06V-301  
(9 Pages)

RE: Notice of Safety Defect in Accordance with 49 CFR Part 573

### Safety Recall Notice # \_\_\_\_\_ Ignition Module Relocation Remedy

## 2005 BULLDOG and 2005-2006 N-CHOPPER/MASTIFF IGNITION MODULE RELOCATION Recall # \_\_\_\_\_

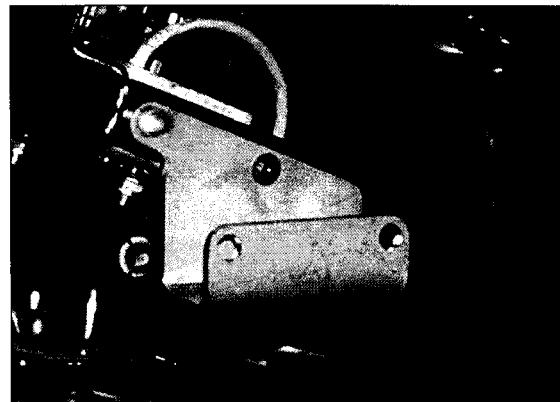
6. Remove the black wire from the circuit breaker and route in front of the EHC.

A. Route ignition module wire here.

**NOTE:** Lift the EHC out of the way to install the ignition module mount.

Typical. Note lock nut position.

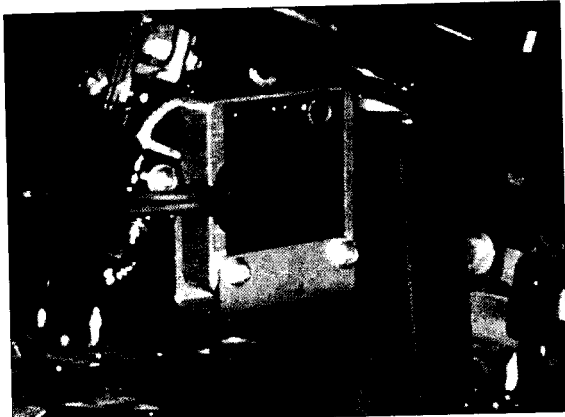
7. Install the ignition module relocation mount using the #10-24 screws and lock nuts provided. Install the front screw with the head facing the EHC, while the rear screw will be installed with the lock nut facing the EHC.

Typical.

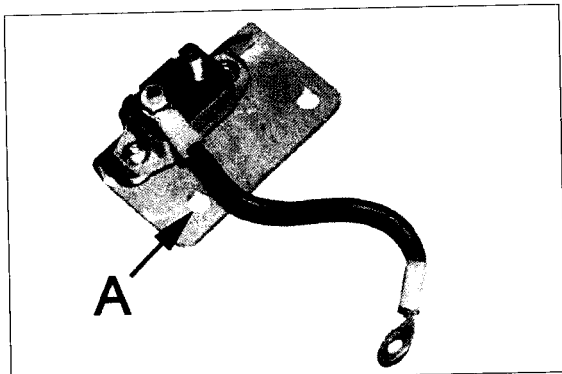
8. Install the ignition module in the mount using the original hardware. Use Loctite 2440 on screw threads. Make sure there is adequate clearance between the oil tank fill neck and the ignition module.

**IMPORTANT:** Over torque on the EHC nylon nuts or connector screws may damage the EHC. **Do not** tighten nylon nuts more than 15 in•lbs.

A. Typical. Circuit breaker and bracket installation.

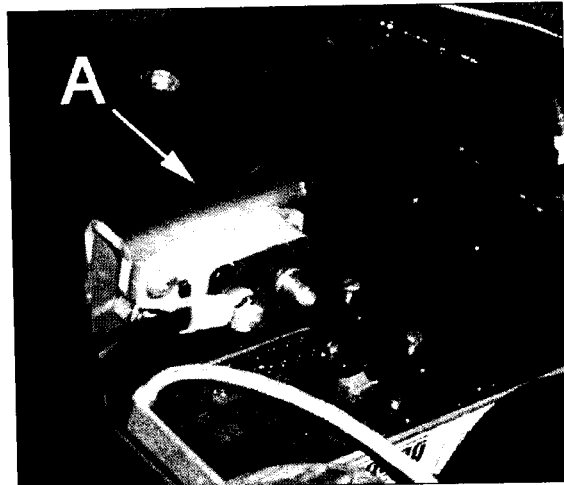
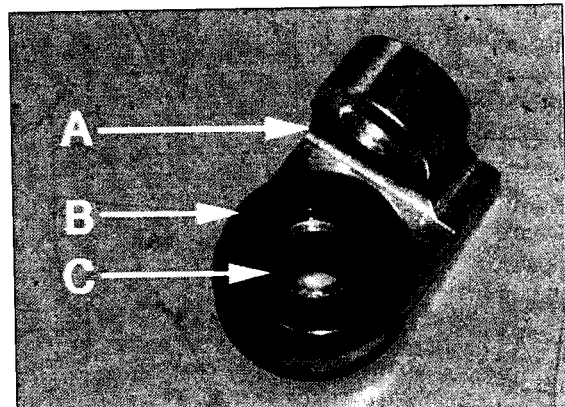
10. Install the circuit breaker on the relocation mount using the previously removed hardware.
11. Loosely install circuit breaker and mount where ignition module was previously located. Install the 1/4-20 x 3/4" screw, washer, and lock nut in the **outer mounting hole only**.

A. Outer mounting hole.

A. Front battery tray mount.  
B. Grommet.  
C. Bushing.

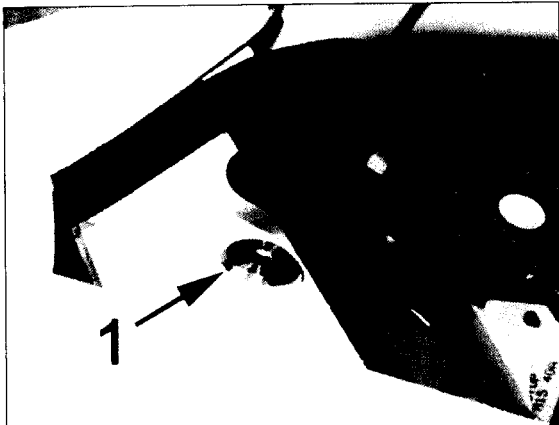
12. Loosen the rear battery tray mounting bolts. Remove and discard the front battery tray mounting bolt and the well nut. These will not be reused.
13. Install the grommet and bushing into the new front battery tray mount.

1. Front battery tray mount.

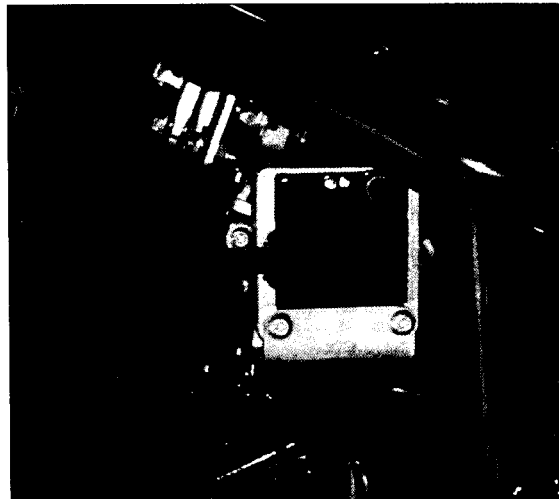
14. Apply Loctite 2760 to the threads of the tray mounting screw (P/N 240-000218-00) and install by placing the screw into the old well nut opening under the front of the battery tray as shown in the next image.

1. Tray mounting screw (P/N 240-000218-00).

**NOTE:** Before fully tightening the tray mounting screw, install the 1/4-20 x 1-1/4" hex screw and fender washer through the front of the battery tray mount as shown in the next image.

15. Loosely install the lock nut.
16. Tighten the tray mount screw through the front battery tray mounting hole with a hex wrench. Torque to 15-20 ft•lbs.
17. Tighten the circuit breaker relocation mount screws. Torque to 5-7 ft•lbs. When fully tightened, the new front battery tray mounting screw should not be in contact with the battery tray.
